CONNECTICUT YANKEE ATOMIC POWER COMPANY

Haddam Neck Plant
TMI-2 Short-Term Lessons-Learned Implementation

HADDAM NECK PLANT

TMI-2 SHORT-TERM LESSONS-LEARNED ITEM 2.1.1

A typical isolation logic and an individual control circuit diagram of CI valve is attached. Drawing Number - 16103-32001 SH 11B and 11BA.

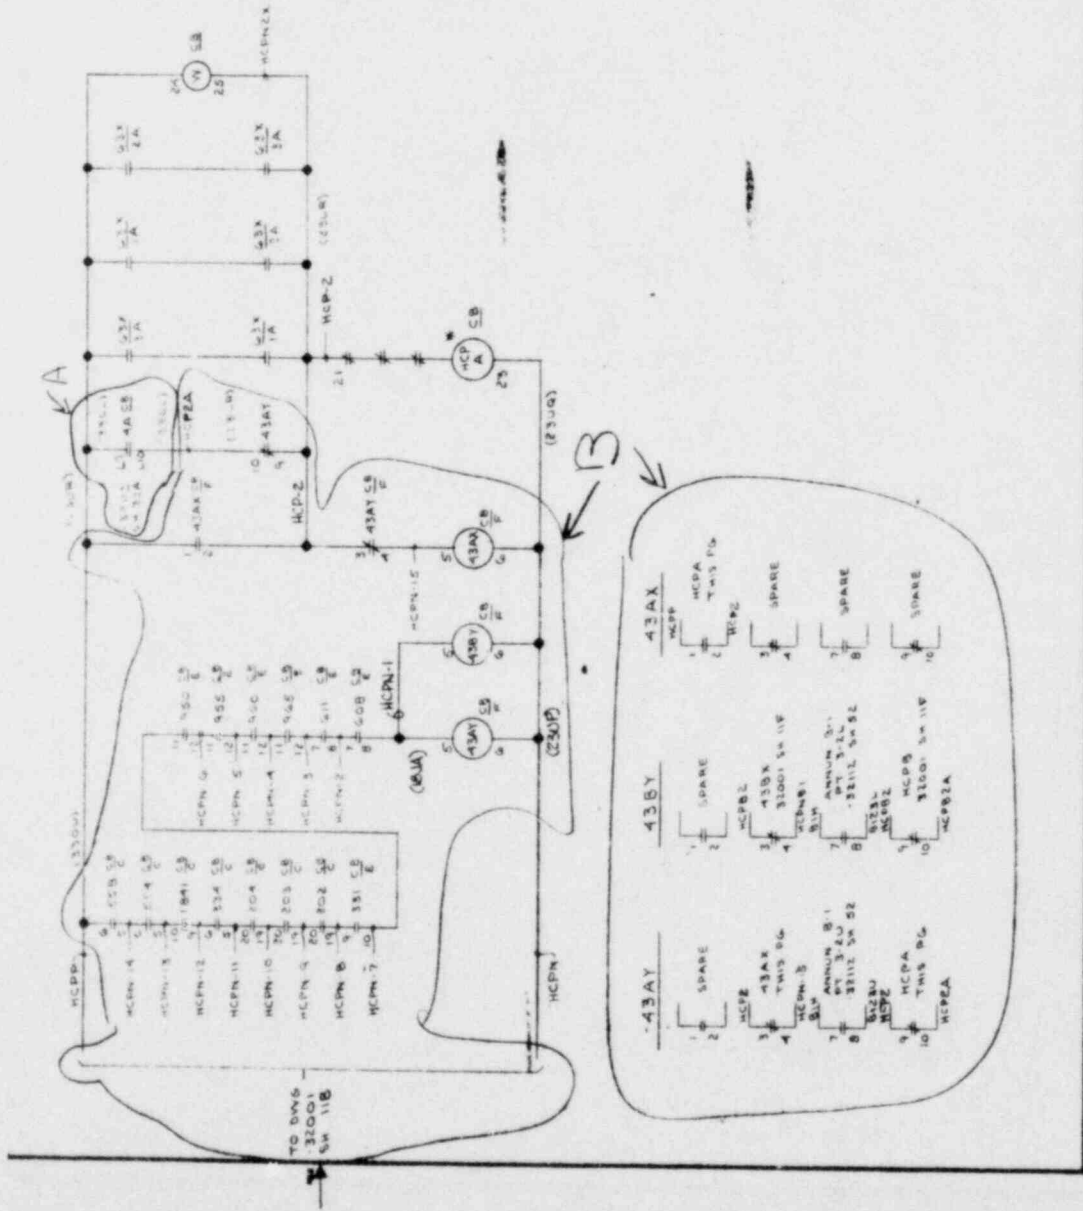
Provide a typical isolation valve control circuit diagram.

A circuit modification was completed on March 28, 1980 to preclude inadvertent valve movements upon reset of the CI actuation signal. This was accomplished by requiring the operator to place the control switches for CI valves into the closed position before CI reset is physically possible. This modification is described in Reference (5) and is illustrated on the attached drawings.

Response
